Joystick Piloting for Outboard System Upgrade

NOTICE
Revised July 2018. This bulletin supersedes the previous bulletin number 2016-11R3 September 2017.
<ul style="list-style-type: none"> • Reflash process changed • Warranty flat rates changed

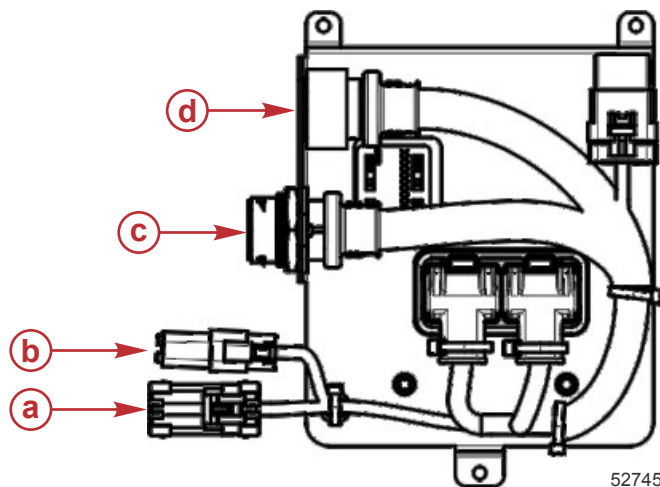
Extension harnesses are available if the mounting location of the sensor is greater than 3 m (10 ft) from the TVM.

TVM panel—old style, before August 2015

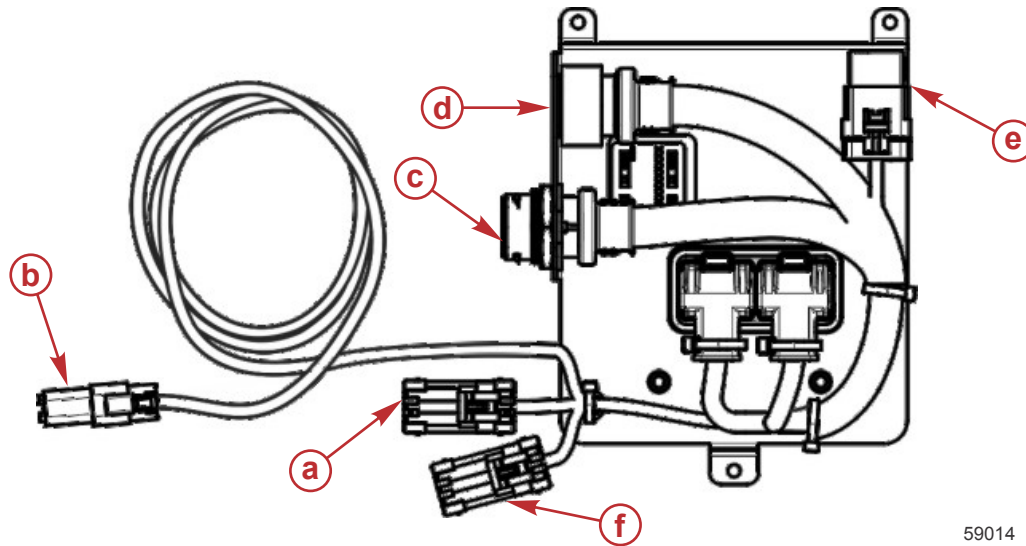
TVM harnesses on units produced before August 2015 must be replaced; they do not have a current sensor connection.

A visual identification of the TVM harness will be necessary to determine if replacement is needed.

NOTE: There is no 4-pin current sensor connector on the old style TVM panel.

IMPORTANT: Old style harnesses must be replaced with the new style. If there was an extension harness installed between the steering actuator and the TVM it must be removed.
